ALERT SERVICE BULLETIN

SUBJECT: OPTIONAL EQUIPMENT - External Mounted Hoist

Unintended detachment of hook assembly from the cable

ASB EC135-85A-069

Figure 1. Hook bumper compression

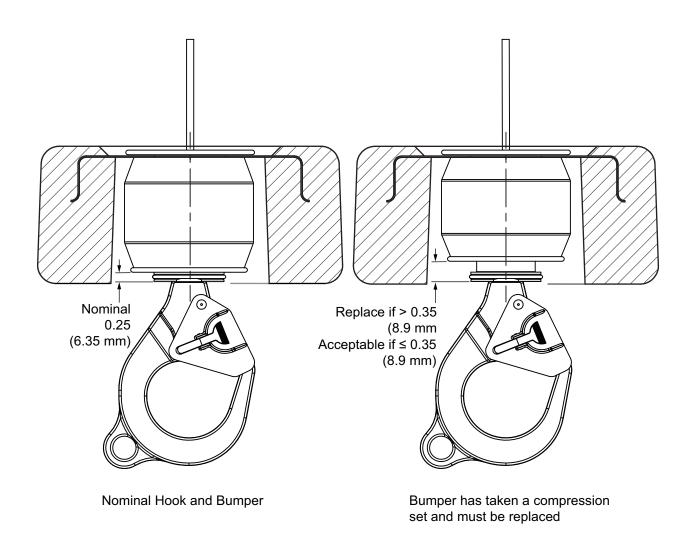
- B. Within five minutes of reeling out the cable in step 2.A, measure the elastomeric energy absorber (bumper) to verify that it hasn't taken a permanent compression set (ref Figure 1).

- If the bumper has taken a permanent compression set, install a new bumper, P/N 42305-290. Refer to CMM 25-00-21-1 for replacement instructions.
- Remove the hook assembly (35, Figure 2) by removing the spring retainer (5) and unscrewing the hook carrier (10) from the body of the hook assembly and set aside.

D-LOK HOOK SHOWN AS AN EXAMPLE.
MEASUREMENT IS THE SAME FOR ALL HOOKS.

Figure 2. Hook Assembly 44301-420, -423

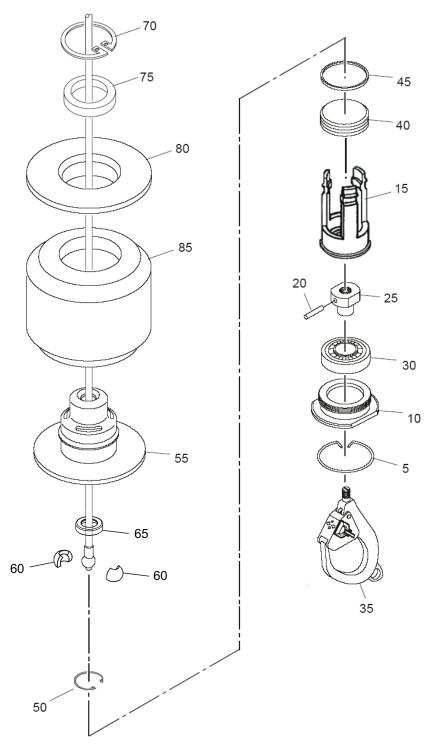
- E. Push the hoist cable into the cable hook retainer (15. Figure 2) and remove the seal cap (40) with attached o-ring (45).
- F. Remove and discard the retaining ring (50).

- If removed, install the spherical seat retainer ring (65, Figure 2) and the split cable retainer (60) on the swaged ball end of the rescue hoist cable. Use the rescue hoist cable to pull the spherical seat retainer ring (65) and the split cable retainer (60) into the lower disc (55). Make sure the assembly is bottomed out in the lower disc (55).

- Install a new retaining ring (50, Figure 2). Visually inspect retaining ring (50) after installation to make sure it is securely installed in its retaining groove (see Figure 3).
- Install the assembled seal cap (40, Figure 2) with o-ring (45) into the lower disc (55). Make I. sure the o-ring (45) is not damaged during installation.
- Reinstall the hook by screwing the carrier into the retainer (15, Figure 2) and installing the J. spring retainer (5).
 - NOTE: The two parts of the carrier (10) and (15) are a matched set (MSL #). When reassembling the carrier, do not intermix components between hook assemblies.
- K. Apply power to the hoist and reel in the hook to the home position. Remove power from the hoist.
